NEW POOL
TERRABELLA POOL
(PROJECT ADDRESS)

SHEET TITLE:
POOL SECTIONS

DRAWING NUMBER:
PL-1.2

B POOL SECTION
SCALE: 3/16" = 1'-0"

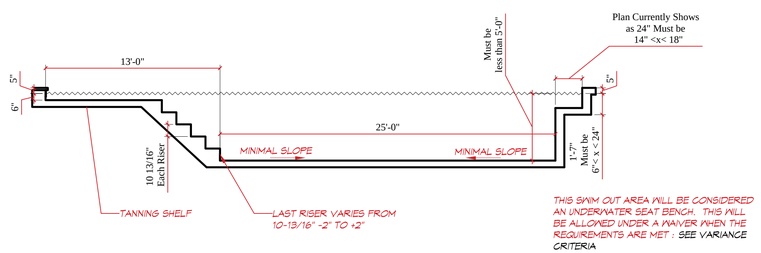
THIS SWIM OUT AREA WILL BE CONSIDERED AN UNDERWATER SEAT BENCH. THIS WILL BE ALLOWED UNDER A WAIVER WHEN THE REQUIREMENTS ARE MET : SEE VARIANCE CRITERIA

THE CODE STATES THAT: Risers at the centerline of the treads shall have a maximum uniform height of 12 inches, with the bottom riser height allowed to vary plus or minus 2 inches from the uniform riser height.
